12V-323
4 PAGES

Noncompliance Information Report relating to Van Hool coaches with driver's seat ISRI 6832/872-NTS

July 9th, 2012

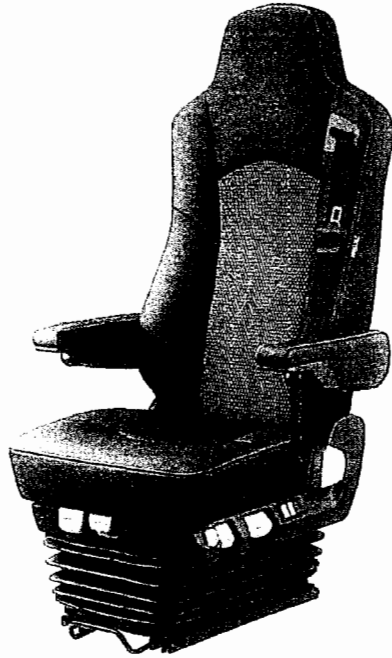
The driver's seat of make Isringhausen and type 6832/872-NTS (photograph below) fulfills the requirements of FMVSS regarding Seating and Seat Belt Assembly Anchorage Systems.

However a spot check by testing revealed that the assembly of driver's seat with riser and floor adapter plate does not fulfill the requirements of §571.207 S4.2. (c) requiring that a force of 20 times the mass of the seat in kilograms multiplied by 9.8 applied in a forward longitudinal direction, in each case applied simultaneously with the forces imposed on the seat by the seat belt assembly when it is loaded in accordance with S4.2 of §571.210.

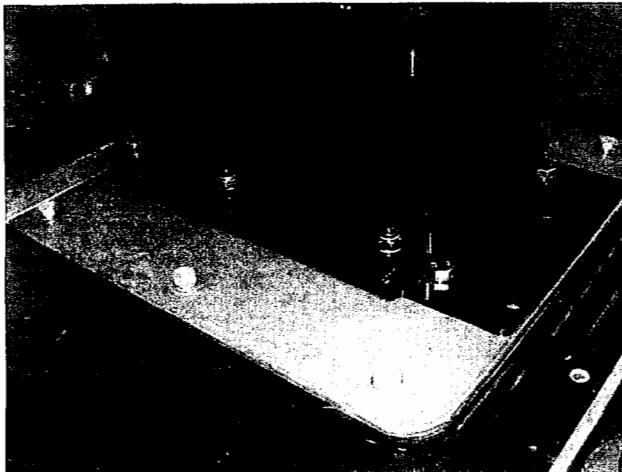
The recall therefore concerns the riser and floor adapter plate used to attach the driver's seat ISRI 6832/872-NTS to the vehicle floor of the recalled vehicles. The respective P/N are VH11307654 and VH11134267 (see photograph below).

The noncomplying riser and floor adapter plate need to be replaced by a complying riser and floor adapter plate : see Van Hool's Service Bulletin.
